SERVICE BULLETIN

SERVICE BULLETIN NO: 28-006 REF NO: IMCL

FUEL - DISTRIBUTION ENGINE DRIVEN PUMP - TORQUE CHECK OF RELIEF-VALVE-BODY SCREWS

Torque Check and Fuel Leak Inspection of the EDP Figure 1

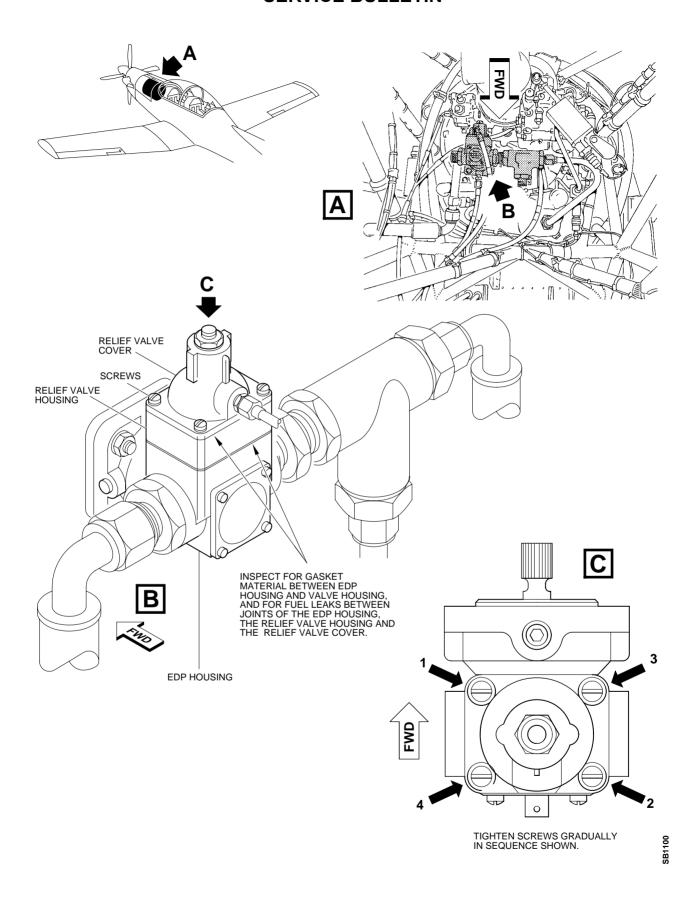
- (1) Open engine cowling ENG 3L and ENG 3R (Ref. AMM, 12-00-00, Page Block 1).
- B. Inspection and Torque Check of the EDP Relief Valve (Ref. Fig. 1)
 - (1) Visually inspect the joints between the EDP housing, relief valve housing and the relief valve cover for:

- Fuel leakage
 - · Gasket material pushed out
 - (2) If the EDP shows signs of fuel leakage or the gasket between the EDP housing and the relief valve housing has been pushed out, replace the EDP (Ref. AMM, 28-20-10, Page Block 401).

- (3) Use a torque screwdriver to do a check of the torque value of the relief-valve-cover screws. Do the check clockwise only. The minimum torque must be 23 lbf in. (2,6 Nm).

- (5) If the relief-valve-cover screws are loose, or the torque found at Step (3) is less than 23 lbf in. (2,6 Nm), do as follows:
 - (a) Cut, remove and discard the lockwire that safeties the relief-valve-cover screws.

- (b) Torque the screws gradually to between 23 and 25 lbf in. (2,6 and 2,83 Nm). Do this in the sequence shown in Figure 1, Detail B.
 - (c) Safety the screws with lockwire (Material Item P02-001).
